Access Compliance Report

Public Rights-of-Way

Intersection ID: 3307	Main Street: SUTTONVIEW_DR	Cross Street: LOOKOUT_POINT_DR	Location: W
ADA ID: AEC63AAF4F07	Ramp Type: Perp	Initial Pass/Fail: Fail	Overall Compliance: No
Severity Score: 13.75			
Codes/Mitigation Info/Possible Solution		Field Measurements/Component Compliance

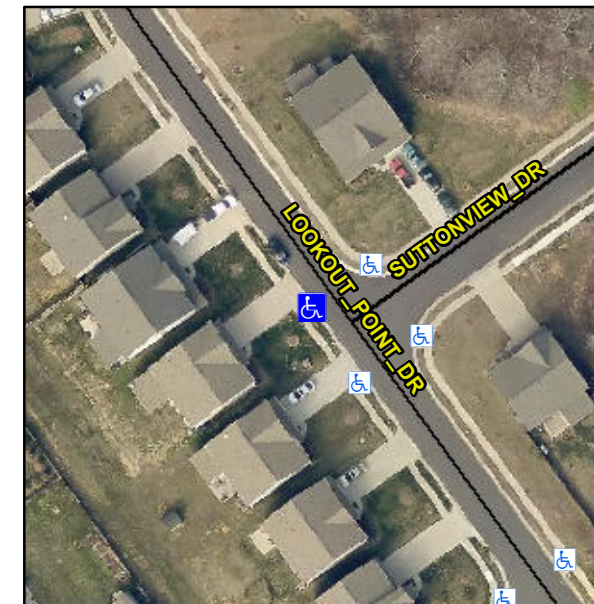
Not Found, R304.2.2, R304.5.3

Compliance	Description	Data	Compliance	Description	Data
N/A	Ramp Length (in)	48.5	No	Ramp Slope (%)	9.0
Yes	Ramp Width (in)	48.0	No	Ramp XSlope (%)	2.2
N/A	Flare Type LT	N/A	N/A	Flare Type RT	N/A
N/A	Flare Slope LT (%)	N/A	N/A	Flare Slope RT (%)	N/A
N/A	Flare Traversable LT?	N/A	N/A	Flare Traversable RT?	N/A
N/A	Landing Length (in)	N/A	N/A	DWS Provided?	N/A
N/A	Landing Width (in)	N/A	N/A	DWS Contrast?	N/A
N/A	Landing Slope (%)	N/A	N/A	DWS Length (in)	N/A
N/A	Landing X Slope (%)	N/A	N/A	DWS Full Width?	N/A
N/A	Landing Curb? (Y/N)	N/A	N/A	DWS Offset (in)	N/A
N/A	Shared Landing?	N/A			
N/A	Gutter Ponding?	N/A	N/A	Gutter Slope (%)	N/A
N/A	Gutter Lip Ht (in)	N/A	N/A	Gutter X Slope (%)	N/A
N/A	Painted X Walk1?	No	N/A	Painted X Walk2?	N/A
	X Walk 1 Direction	To NE		X Walk 2 Direction	N/A
N/A	X Walk 1 Width (in)	N/A	N/A	X Walk 2 Width (in)	N/A
	X Walk 1 Slope (%)	1.9		X Walk 2 Slope (%)	N/A
	X Walk 1 X Slope (%)	1.3		X Walk 2 X Slope (%)	N/A

Remove & Replace Entire Ramp.
